Re: TEDS Exceptions, 2793 Skyline Court

TEDS EXCEPTIONS 2793 SKYLINE COURT

DESIGN EXCEPTION #DE 6-17, 18 &19

RE: 2793 Skyline Court

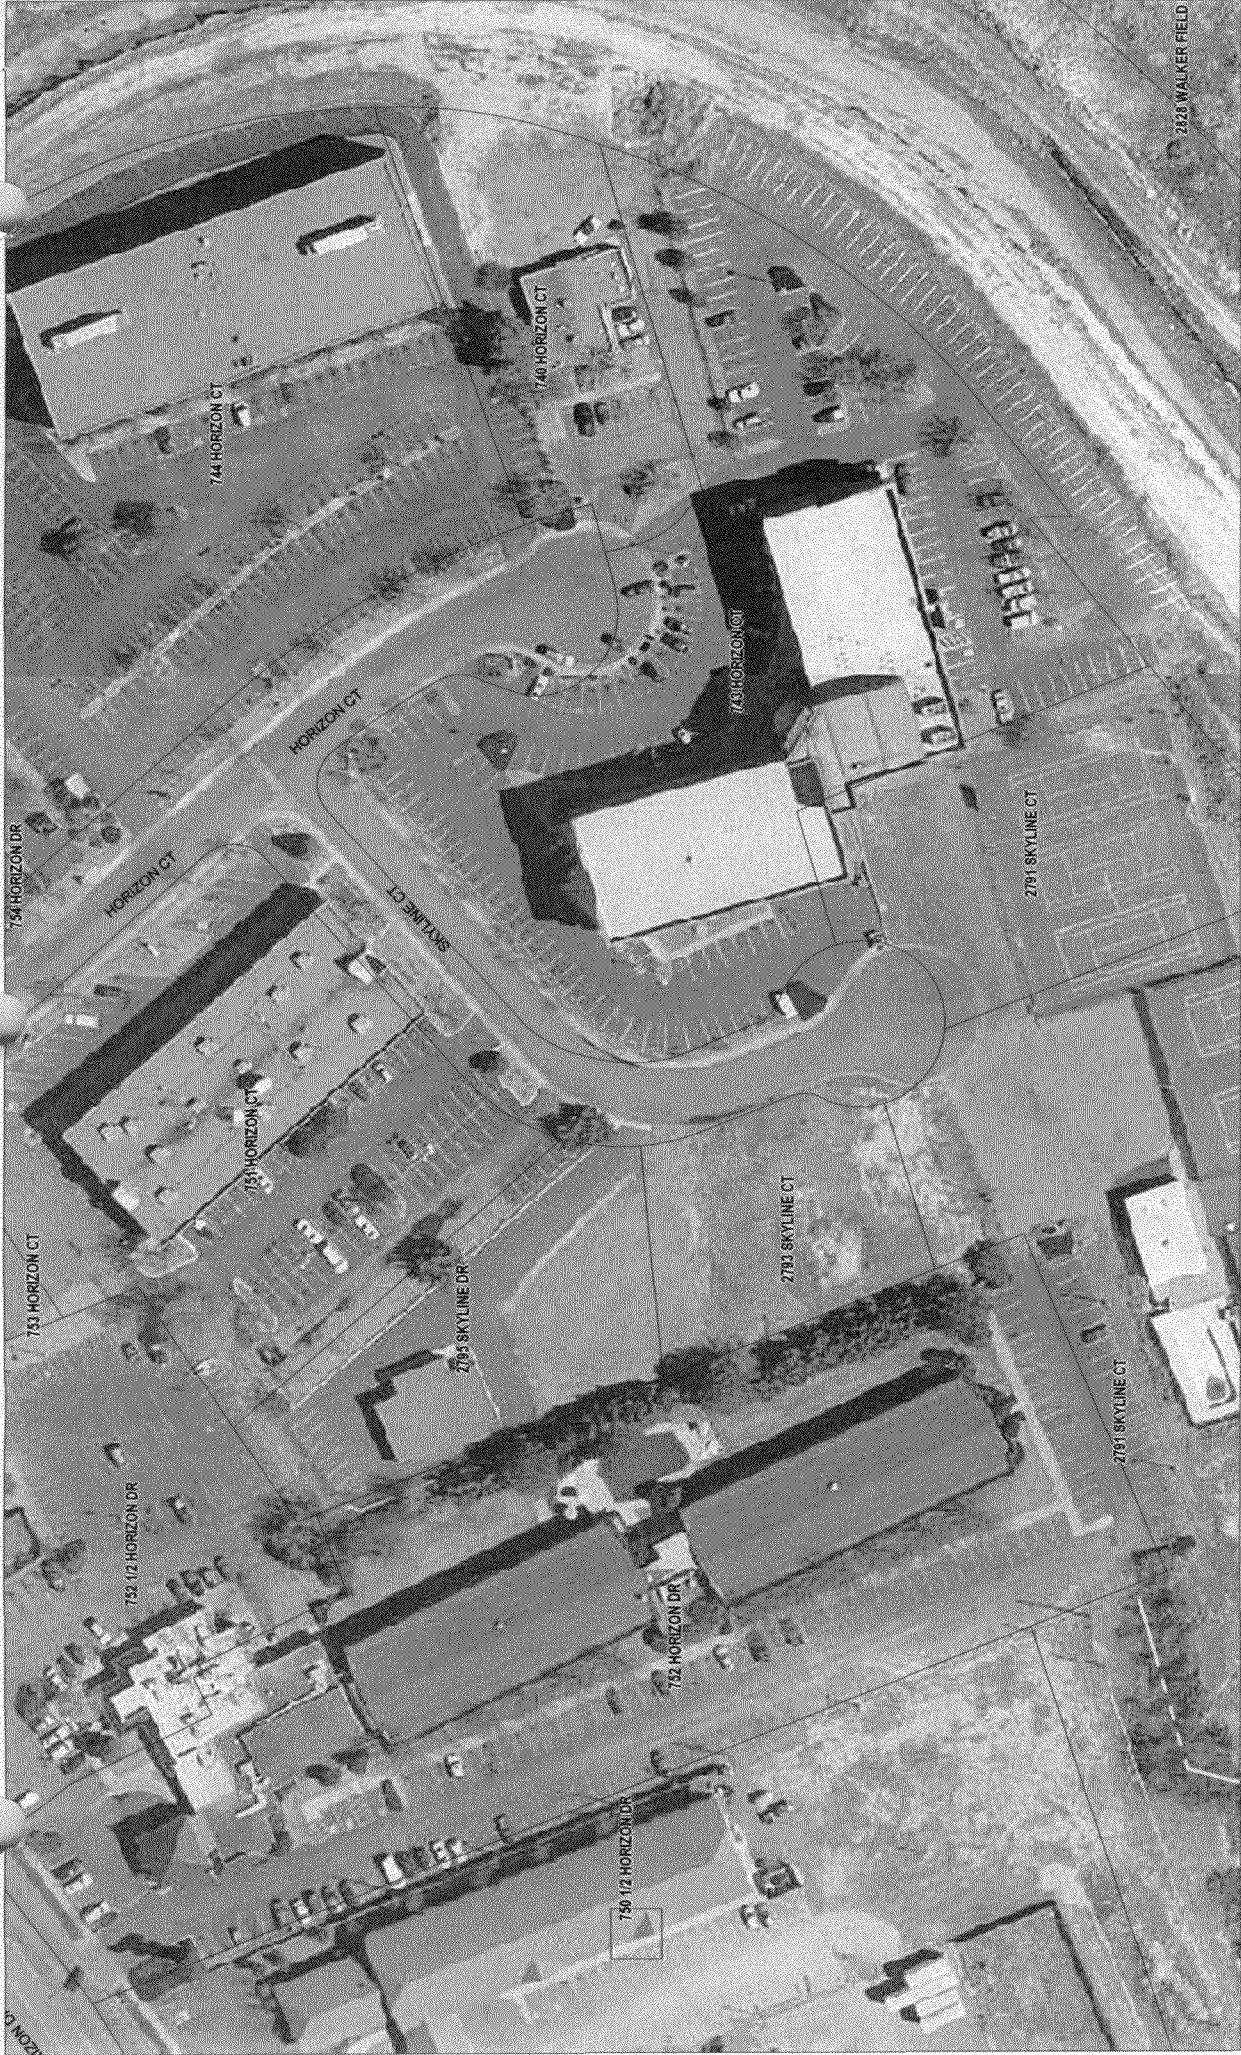
The proposed driveway has 16 feet of separation from the nearest driveway to the south. Section 4.1.1 of TEDS requires a minimum of 50 feet on local commercial streets.

Skyline Court is designated a local commercial street with a right-of way requirement of 52 feet of right-of-way. The existing right-of-way is 50 feet wide.

We are proposing to grant a 12 foot multipurpose easement overlaying the existing 6-foot utility easement.

This request goes hand in hand with the right-of-way request. The distance from the back of sidewalk to the outside of the 12 foot easement (15 feet) will be the same if we do not dedicate the 1 foot and the street is never widened (See section on site plan).

- The City of Grand Junction has allowed less than a 14 foot wide Multi-Purpose easement in locations where there is sufficient room between the adjacent street improvements and the edge of right of way. In this instance, there will be an additional 2 – 3 feet of room between the top back of the new sidewalk and the existing right of way line (refer to attached site plan)

Staff recommends approval of the three requested exceptions. Staff agrees that Skyline Ct. appears to function adequately even though it provides less than the standard pavement width for a Local Commercial roadway when considering the amount of adjacent off-street parking available along Skyline Ct. Commercial roadways typically allow on-street parking which requires additional pavement width.

-Staff agrees that providing a 12 foot wide Multi-Purpose easement, when combined with the additional 2 – 3 feet of width available in the right of way, will provide adequate room for utility providers to place dry utilities when needed in the future.
